# UNITED STATES PATENT AND TRADEMARK OFFICE

APPLICATION NO.	FILING DATE	FIRST NAMED INVENTOR	ATTORNEY DOCKET NO.	CONFIRMATION NO.
10/711,593	09/28/2004	Mark D. Fairchild	P04-01	5592
25759	7590	06/25/2007	EXAMINER	
JOHN J. ELNITSKI, JR. 225 A SNOWBIRD LANE BELLEFONTE, PA 16823			LEE, BENJAMIN P	
		ART UNIT	PAPER NUMBER	
		3641		
		MAIL DATE		DELIVERY MODE
		06/25/2007		PAPER

<b>Office Action Summary</b>	Application No.	Applicant(s)
	10/711,593	FAIRCHILD, MARK D.
Examiner	Art Unit	
Benjamin P. Lee	3641

**DETAILED ACTION**

*Fig.1.**Fig. 2.**Fig. 3.****Allowable Subject Matter***

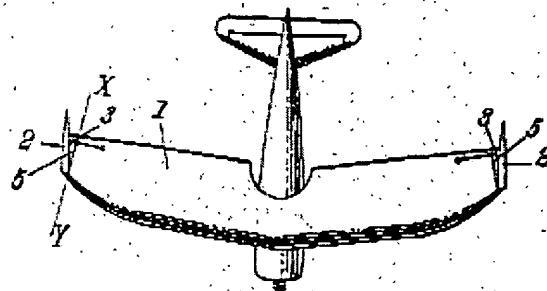
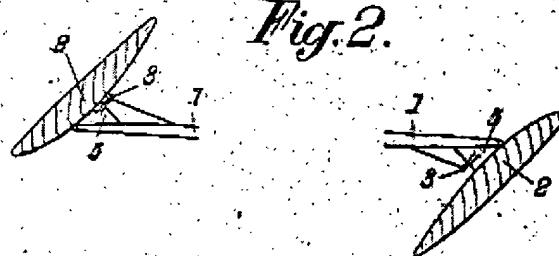
induced drag differential overcomes adverse yaw produced by the outboard wing (col. 1, lines 18-53). Note that Richard et al disclose manipulating "end-plates" on each wing to induce yaw. Although these "end-plates" do not necessarily increase the effective aspect ration of the wings, they do create a moment force via an induced drag differential between the inboard and outboard wings. **The induced drag is an inherent consequence of allowing stronger wing-tip vortices to form from the bottom of the inboard wing to the top.** Note that there is no limitation on the level of adverse yaw produced and it is reasonable to assume that a relatively small aileron deflection will create a comparably small degree of adverse yaw.

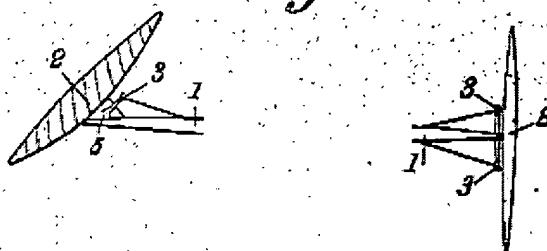
5. In regards to claim 2, Richard et al disclose that the net induced drag differential is produced by controlling the aircraft such that the induced drag experienced by the inboard wing is greater than the induced drag experienced by the outboard wing (see fig. 3 following). Note that the left (inboard) wing "end-plate" is pivoted and the right ("outboard") wing "end-plate" is in a "neutral" position. The pivoted "end-plate" induces greater drag than the "neutral" plate.

"end-plate" on the right ("outboard") wing spoils or blocks the wingtip vortex reducing downwash and the pivoted "end-plate" on the left ("inboard") wing allows a wingtip vortex increasing downwash.
